Lubecore Communication

Subject: Progressive Divider Valves – Outlets 1 & 2

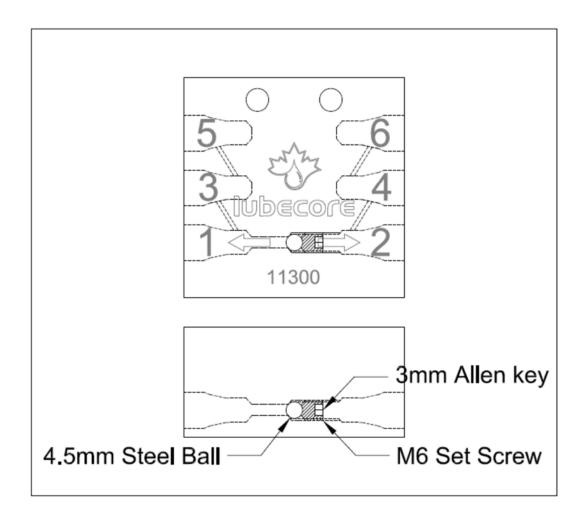
The following drawing shows outlets 1 & 2 with common channel blocked by steel ball and set screw. Using a 3mm allen key, remove set screw and ball from **Outlet 2**. Install outlet plug 20.205 into one of the outlet ports. Grease from both will now go to remaining outlet. This affects all divider valves with Lubecore logo as shown. Part numbers 11.300, 11.301, 11.302, 11.303 and 11.297 with logo.

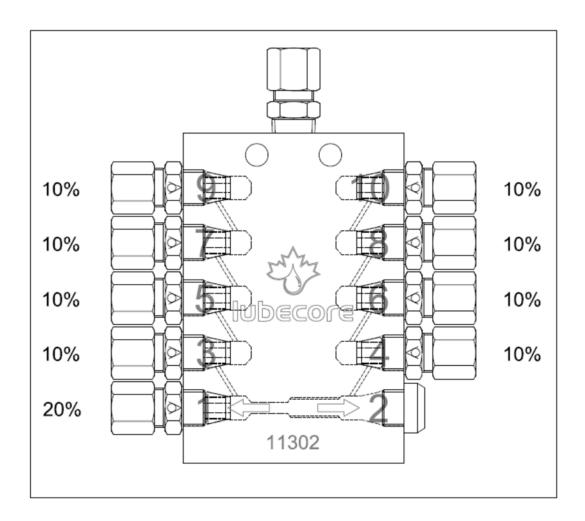
The drawing below shows equal division outlets 3-10. Removing the set screw and ball, and installing an outlet plug 20.205 in outlet 2 directs grease from 1 & 2 to outlet 1 - 20%

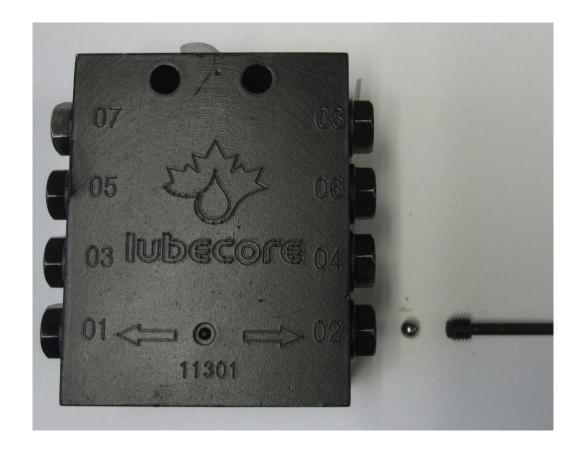
Actual ball and set screw removed from outlet 2.

Previous method of collecting outlet delivery 1 & 2, now used only with dividers without logo.
